**From:** Scott, Adam <AdamScott@hoarelea.com>  
**Sent:** 13 January 2026 15:03  
**To:** Jamie Loxley  
**Cc:** Matthew Thomas  
**Subject:** Re: 31794 - Navigator Quarter, Southampton Airport

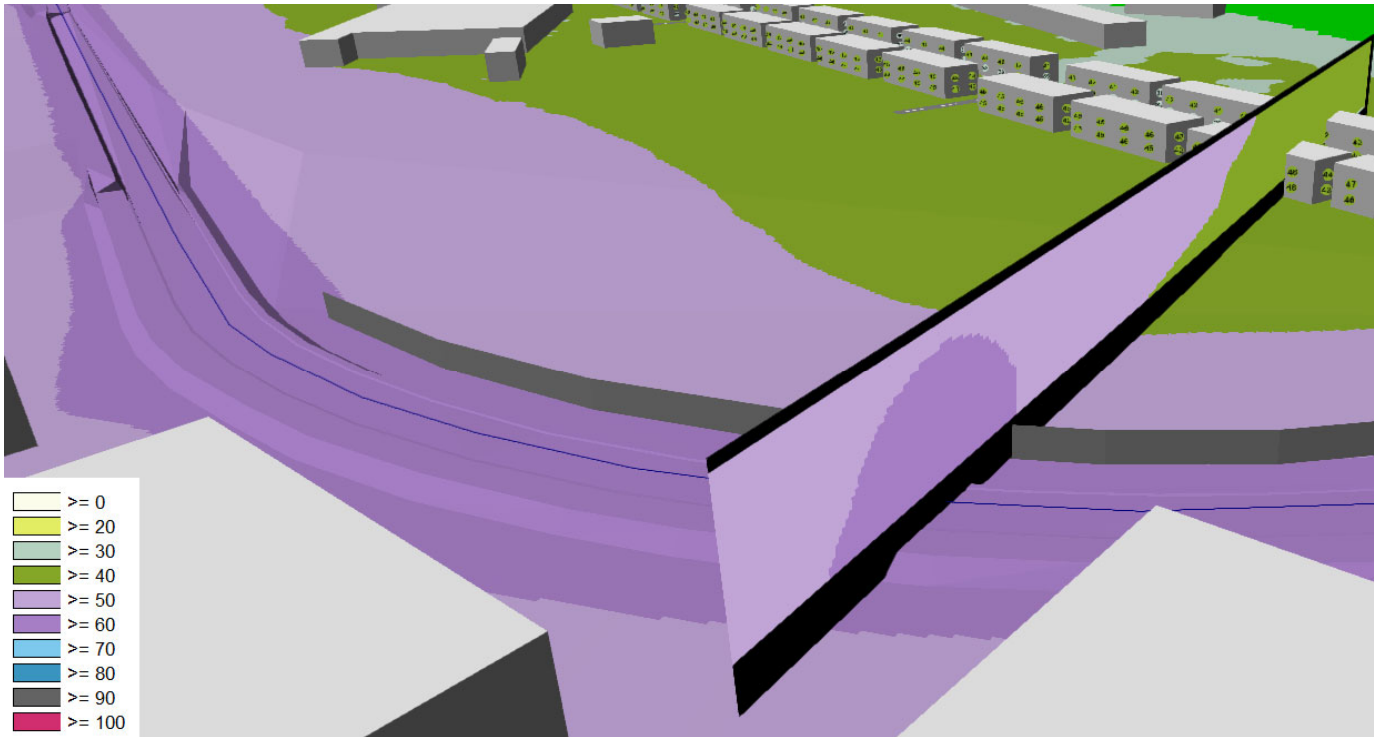
With the inclusion of a barrier, as shown in the noise map below, the updated assessment complies with BS 8233 desirable internal noise levels. This is based on nearby receptors having their windows open as a conservative case.

If you can advise that the ecologist is happy then we can conclude that the proposed barrier enables noise levels to comply with guidance criteria within the constraints of other requirements for the development.
